U.S. ENVIRONMENTAL PROTECTION AGENCY REGION 10

March 17, 1989

Re: Comments on Remedial Investigation / Feasibility Study Work Plan for the 1100-EM-1 Operable Unit

Figure 1. RI/FS Schedule for 1100-EM-1 Operable Unit

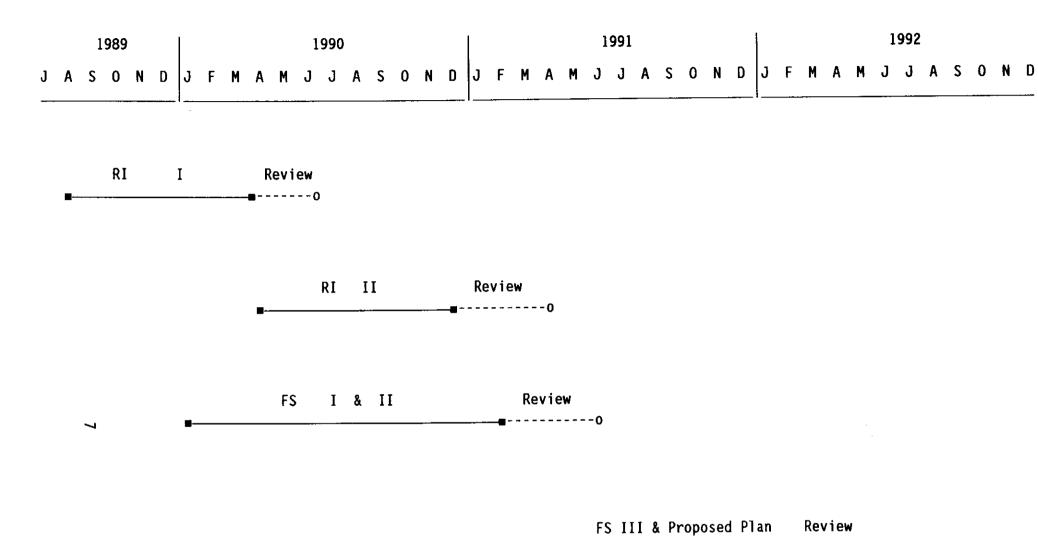
Recommendation for Revised RI/FS Schedule

The following is a realistic schedule for completion of the RI/FS process at the 1100-EM-1 operable unit. All dates are end of month dates (e.g., August 1989 equals August 31, 1989). A graphic presentation of this schedule is included on Figure 1. Given the site specific characteristics of the operable unit, this schedule is achievable through incorporation of the comments in this document.
